Item Name: Crosstube Turning Detail

DART AEROSPACE LTD	Work Order:	85988
Description: Crosstube Assembly (412 High Aft)	Part Number:	D412-664-243
Inspection Dwg: D412-664-243 Rev: E		Page 1 of 2

DRAWING NO. D412-664-243	TITLE CROSSTUBE ASSEMBLY (412 HI AFT)	REV. E	DART AEROSPACE LTD ENGINEERING ORDER		D.E.O. NO. D412-664-243-E-1	SHEET NO. SHEET 1 OF 2	SCALE NTS
DRAWN	CHECKED	MFG. APPR.	APPROVED	DE APPR.			
DATE 11.03.31	DATE 11/03/31	DATE 11.03.31	DATE 11/03/31	DATE 11-03-31

DRAWING NO. D412-664-243	TITLE CROSSTUBE ASS'Y (412 HI AFT)	REV. E	DART AEROSPACE LTD ENGINEERING ORDER		D.E.O. NO. D412-664-243-E-2	SHEET NO. SHEET 1 OF 1	SCALE NTS
DRAWN <i>MP</i>	CHECKED <i>ASS</i>	MFG. APPR. <i>RE</i>	APPROVED <i>MP</i>		DE APPR. <i>MP</i>		
DATE 11.09.07	DATE 11.09.19	DATE 11.09.19	DATE 11.09.19		DATE 11.09.19

D212-664-243
ASSEMBLY DETAIL

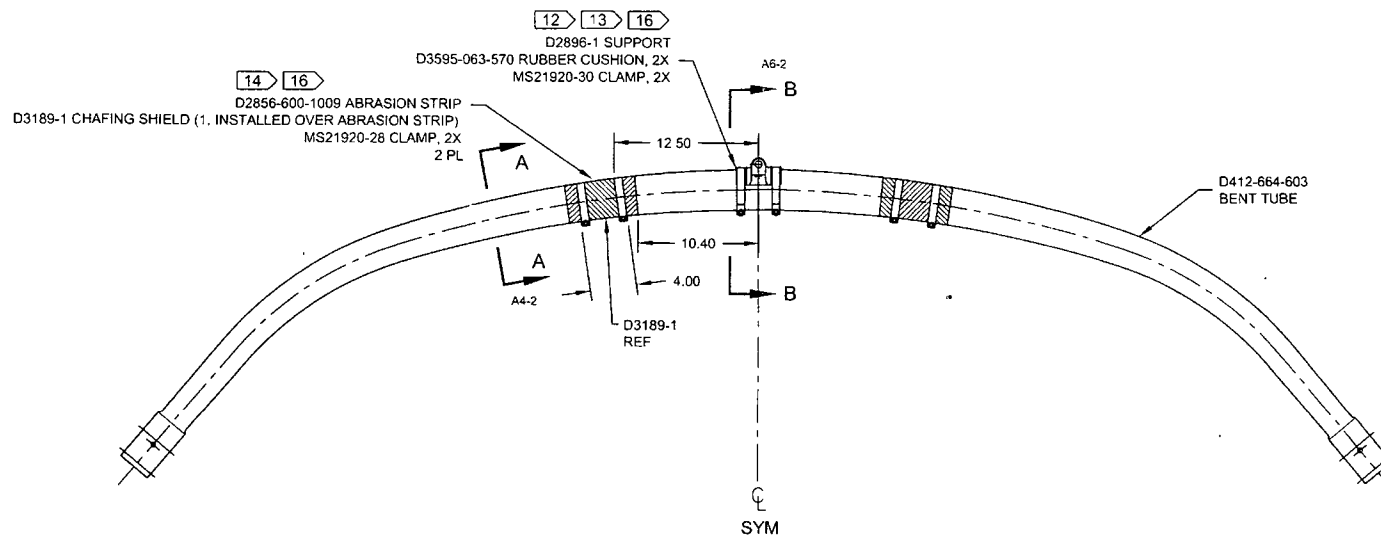
PURPOSE:

REMOVED ABRASION STRIP IN FAVOR OF A THIN LAYER OF PROSEAL 890.

NOTES 2 AND 14, SHEET 1 ARE AMENDED AS FOLLOWS:

IS:

WAS:

D2856-600-1009 ABRASION STRIP
D3189-1 CHAFING SHIELD (1, INSTALLED OVER ABRASION STRIP)
MS21920-28 CLAMP, 2X
2 PL

- 2) FINISH: CHEMICAL CONVERSION COAT PER DART QSI 005 4.1
PRIME INSIDE AND OUTSIDE PER DART QSI 005 4.2
MASK UNDERSIDE OF CROSSTUBE AS SHOWN (HATCHED AREA)
PAINT OUTSIDE PER DART QSI 005 4.2
AFTER PAINTING, APPLY CLEAR COAT ON HATCHED AREA
- 14) APPLY A THIN COAT OF PROSEAL 890 ON INSIDE CONCAVE SURFACE OF D3189-1
CHAFING SHIELD AND LET CURE PER MANUFACTURER'S INSTRUCTIONS. INSTALL
PROSEALED D3189-1 CHAFING SHIELD ONTO CROSSTUBE BY APPLYING A THIN COAT OF
PROSEAL 890 ONTO CROSSTUBE. BE SURE TO ELIMINATE ANY AIR GAPS.

D3189-1 CHAFING SHIELD (1, INSTALLED OVER PROSEAL 890)
MS21920-28 CLAMP, 2X
2 PL

2
MASK AREA PRIOR TO PAINTING AND
APPLY CLEAR COAT AFTER PAINTING
